Technical Report

ROM UPGRADE..... (10)

1. Model Name: BP-C131WD, BP-C131PW

2. Description: Upgrade of MCU-MAIN, PCU -ROM

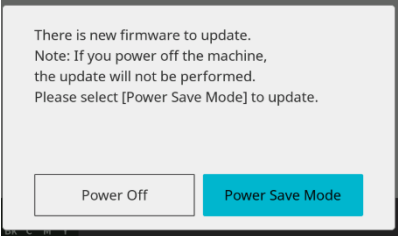
No.	Item	Detail
1	Specification	Changed the notification behavior when the power is turned off while online firmware update is enabled. ■ Message displayed when updated firmware is available at power-off: There is new firmware to update. Note: If you power off the machine, the update will not be performed. Please select [Power Save Mode] to update. [Power Off][Power Save Mode]
